MIL-T-81978(AS)

Amendment 2
1 December 1976
SUPERSEDING
Amendment 1
9 July 1975

MILITARY SPECIFICATION

TEST SET, MISSION RECORDER AN/USM-387

FIG. 8 AN/USM-387B CABLING DIAGRAM

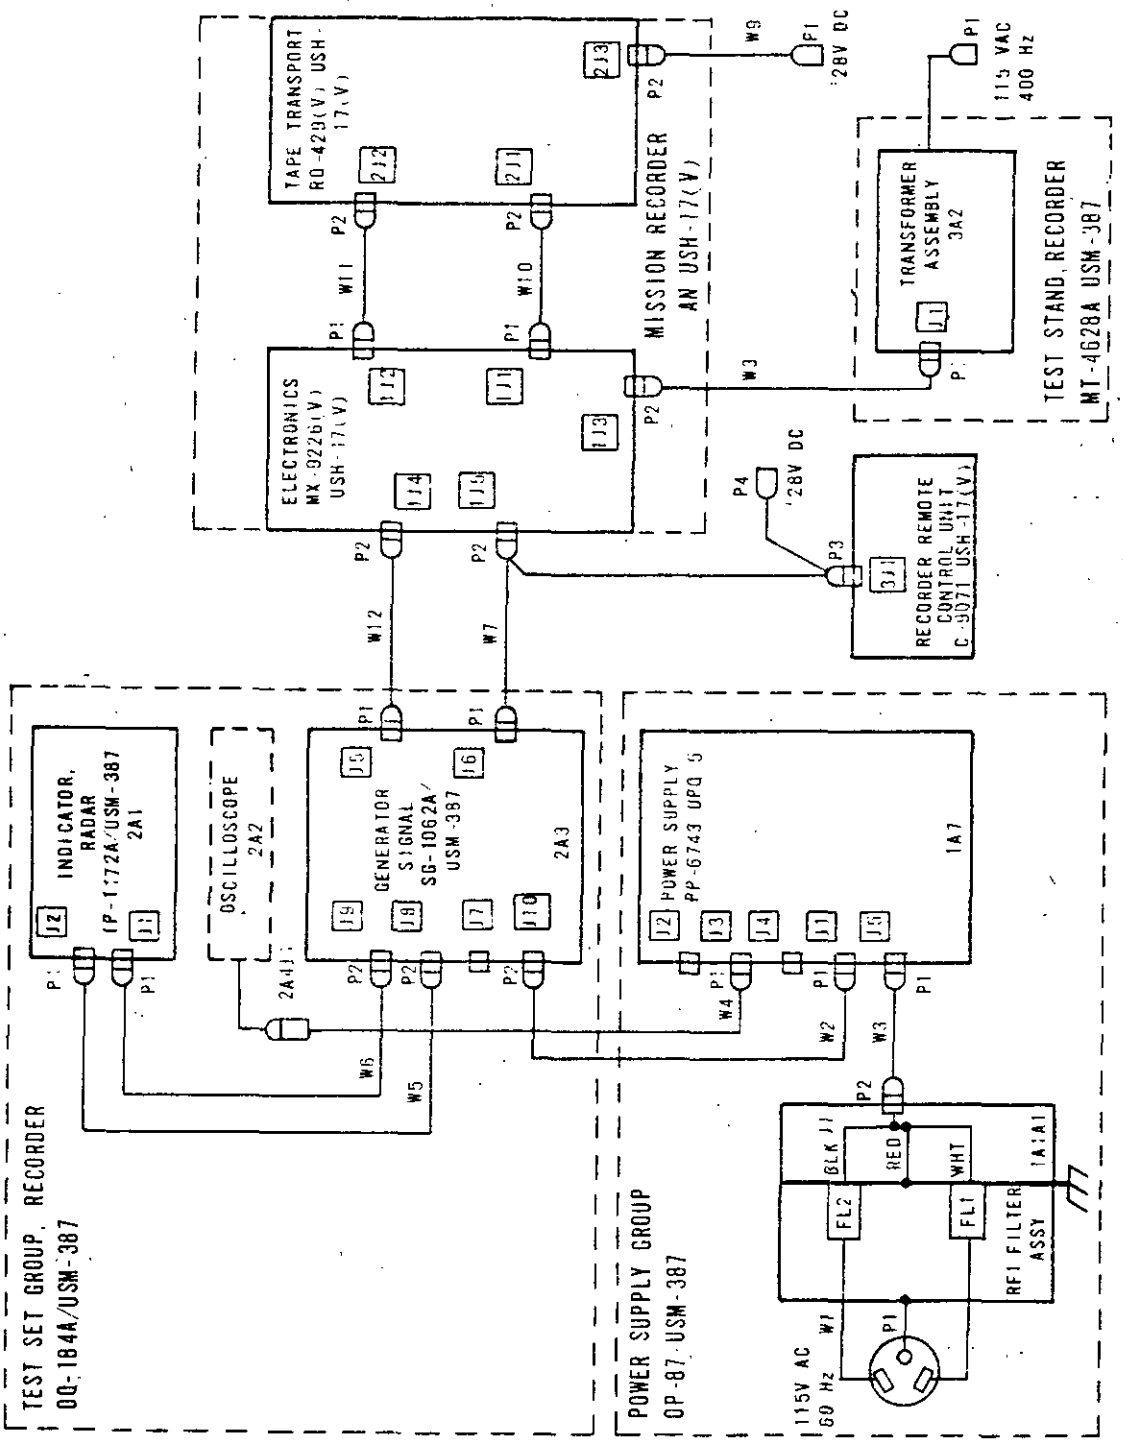
*Delete Figure 9 and replace with modified Figure 9 contained herein.
